UNITED STATES DEPARTMENT OF COMMERCE  
Patent and Trademark Office

**Office Action Summary**

This is the first office action for application number 09/629,241, Wiring Clip for Securing Electrical Wiring to a Framing Member, filed on July 31, 2000.

FIG. 1

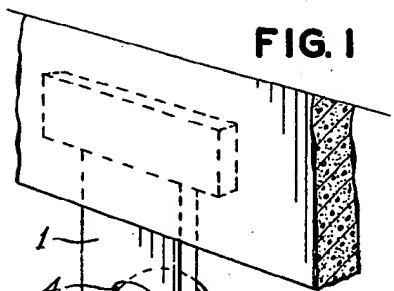
Claims 1, 5-10 and 12-13 are rejected under 35 U.S.C. 102(b) as being anticipated by U.S. Patent 2,631,809 to Jacobson. Jacobson discloses a wiring clip 5 (note attached marked-up copy of Figs. 1-2) including the following: a main body 5,5a,6,6a,7,7a; a wire receiving area A1 adjacent the main body; and, first and second arms 14a,12a each with respective first and second attachment means for attaching 14,12 located at first and second ends respectively. Jacobson also discloses that the first and second attachment means has a J-hook and a bend respectively. Finally, Jacobson disclose that the clip is dimensioned and made of thin metal or plastic for allowing a screw to penetrate the clip.
